Access Compliance Report

Public Rights-of-Way

Intersection ID: 53918	Main Street: VISTA_WOODS_LN	Cross Street: BRITTONDALE_LN	Location: E
ADA ID: 15D238CC3580	Ramp Type: BlendTrans1	Initial Pass/Fail: Fail	Overall Compliance: No
			Severity Score: 36.25

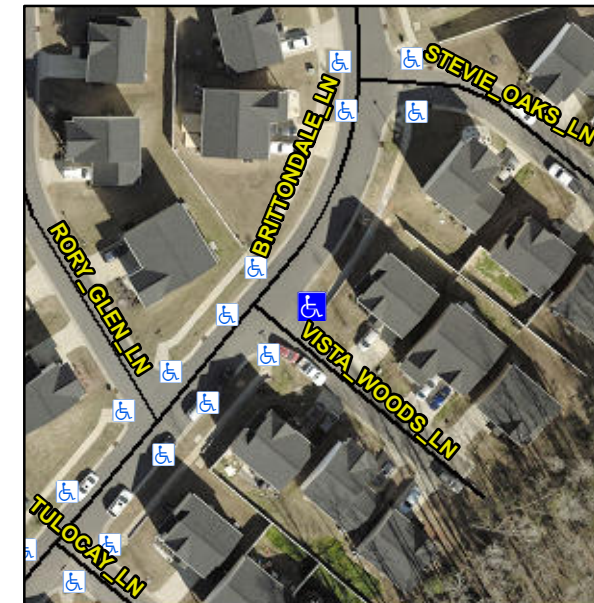
NO RT SW

Not Found, R304.5.1, R304.5.3

Compliance	Description	Data	Compliance	Description	Data
N/A	Ramp Length (in)	70.0	Yes	BlendTrans Slope (%)	3.1
No	Ramp Width (in)	31.5	No	BlendTrans XSlope (%)	3.8
N/A	Flare Type LT	N/A	N/A	Flare Type RT	N/A
N/A	Flare Slope LT (%)	N/A	N/A	Flare Slope RT (%)	N/A
N/A	Flare Traversable LT?	N/A	N/A	Flare Traversable RT?	N/A
N/A	Landing Length (in)	N/A	N/A	DWS Provided?	N/A
N/A	Landing Width (in)	N/A	N/A	DWS Contrast?	N/A
N/A	Landing Slope (%)	N/A	N/A	DWS Length (in)	N/A
N/A	Landing X Slope (%)	N/A	N/A	DWS Full Width?	N/A
N/A	Landing Curb? (Y/N)	N/A	N/A	DWS Offset (in)	N/A
N/A	Shared Landing?	N/A			
N/A	Gutter Ponding?	N/A	N/A	Gutter Slope (%)	N/A
N/A	Gutter Lip Ht (in)	N/A	N/A	Gutter X Slope (%)	N/A
N/A	Painted X Walk1?	No	N/A	Painted X Walk2?	No
	X Walk 1 Direction	To NW		X Walk 2 Direction	To SW
	X Walk 1 Width (in)	N/A		X Walk 2 Width (in)	N/A
	X Walk 1 Slope (%)	1.8		X Walk 2 Slope (%)	2.0
	X Walk 1 X Slope (%)	3.7		X Walk 2 X Slope (%)	3.3

N/A	Ramp inside XWalk1?	N/A	N/A	Ramp inside XWalk2?	N/A
	Road Slope (%)	5.1		Clear Space?	N/A
	Road X Slope (%)	1.5	N/A	Clear Space to XWalk (in)	N/A
N/A	Any Obstructions?	N/A	N/A	Storm Grate/Utility Hazard?	N/A
	Obstruction Type			Storm Grate/Utility Type	
		N/A			N/A
			Yes	Surface Condition? (G/P)	Good
			No	Curb Slope (%)	9.8

Possible Solutions:

Remove & Replace Curb Ramp With Two New Directional Ramps or Equivalent.
